# WATER SUPPLY CONTRACT EXTENSION PROJECT

# FINAL ENVIRONMENTAL IMPACT REPORT

**November 2018**

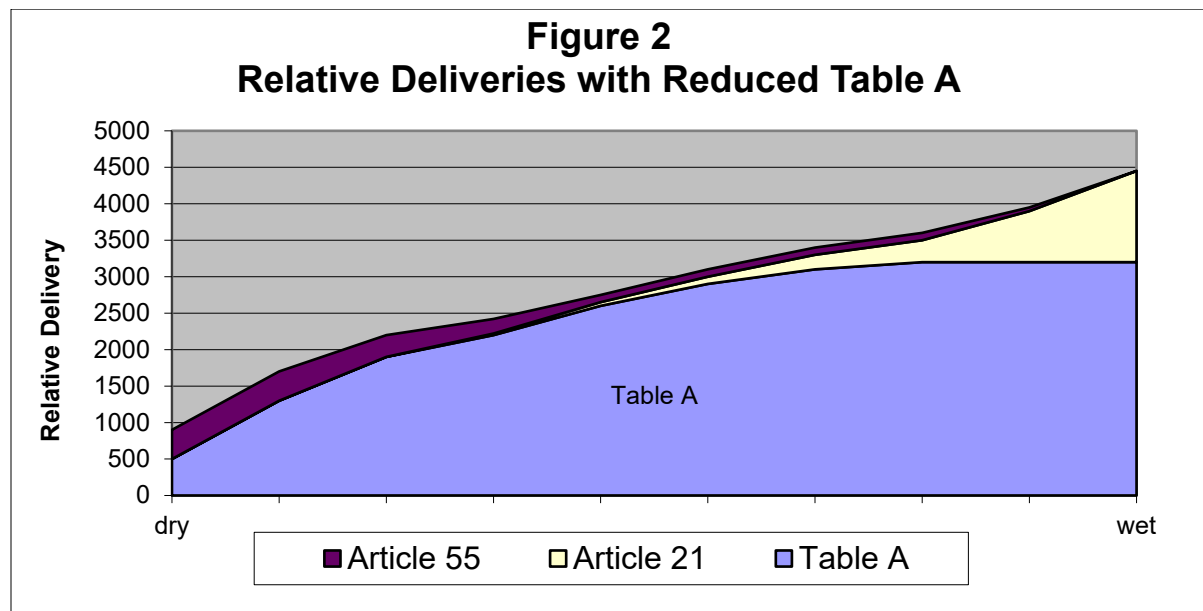
Scenario 1 is a reduction in Table A amounts to 3.2 MAF per year. Figure 2 illustrates that other types of water would be requested by Contractors to make up the reduction. If Table A amounts were reduced in the Contract, it would not change the amount of water

Assuming no limitations to Article 21 deliveries, reduction of Table A amounts would mean that the relative deliveries of Table A amounts and Article 21 water would be different, but would not necessarily result in a reduction in the total amount of SWP water exported from the Delta. Article 21 supplies would increase, and the SWP would use available capacity to move water to storage south of the Delta for future allocation such that reservoirs South of the Delta would be fuller more often. Such changes in Article 21 deliveries would alter the distribution of water among the Contractors to the benefit of some and detriment of others. This differential impact occurs because Article 21 water is only available under certain conditions that generally occur only in the winter and early spring. Those Contractors that do not have sufficient storage capabilities or other immediate beneficial use of the water cannot accept delivery. Those that have such capabilities then get an added share when the water is allocated.

**Figure 4: Probability of Exceedance for Table A Deliveries**

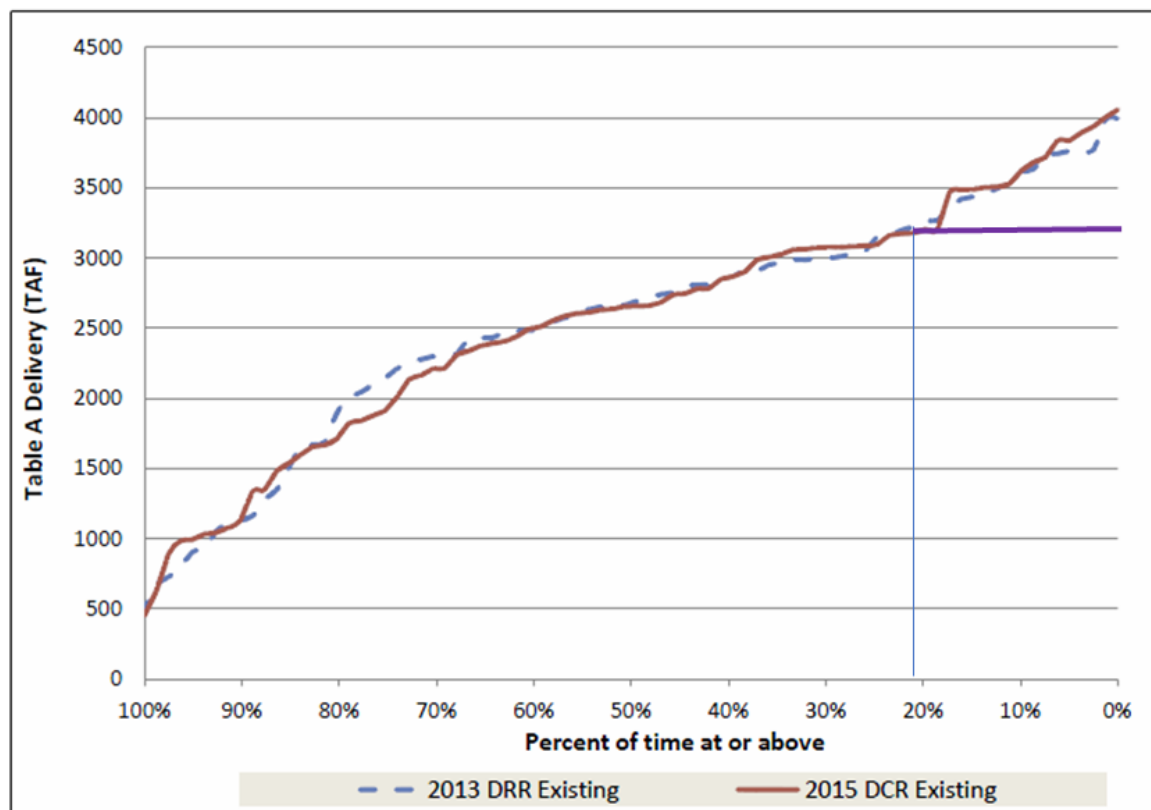
Using DCR Appendix B, Figure B.4 (delivery probability figure; 2015 conditions), a vertical blue line was drawn to mark a reduced Table A delivery at 3.2 MAF. Figure 4 illustrates only the estimated Table A deliveries, and contains an added horizontal line drawn at 3.2 MAF, and vertical line illustrating the delivery probability of the point where the cap would take effect on Table A supplies. Figure 4 shows that 79 percent of the time Table A deliveries would be less than 3.2 MAF, and Contractors would be unaffected by this scenario. However, 21 percent of the time Contractors would be affected by imposing this permanent reduction of Table A deliveries, with a reduction of 800 taf in the wettest of years (~4,000-3,200 taf). Additionally, this scenario assumes that they could not make up the difference with Article 21 deliveries exported from the Delta.

Limiting Table A deliveries to 3.2 MAF would decrease average annual SWP Table A deliveries by about 84 TAF. Table A deliveries would average somewhat less than the about 2,077 taf shown in DCR Figure 5-1 on page 2-15 of this FEIR, probably reduced to about 1,993 TAF per year.
